LUBBER RUN AMPHITHEATER (LRA) SITE AND FACILITY ASSESSMENT

Conducted By LRA Community Supporters

March 27, 2011

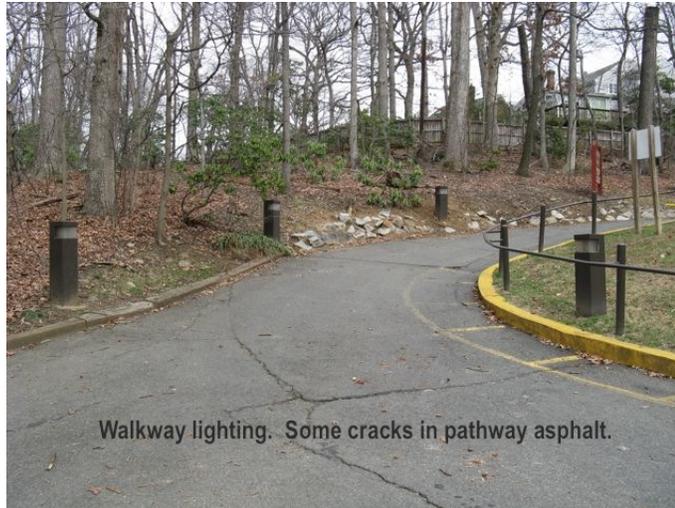
a. A narrow asphalt depression crosses the entry path. It reaches a depth of 1.5 inches in a section near the handrail and should be patched. Additional portions of the asphalt path are in poor condition and should be repaired. The open hole that seats a metal pole meant to prevent unauthorized vehicle access could be filled since the pole is often missing. (photo 2.a)
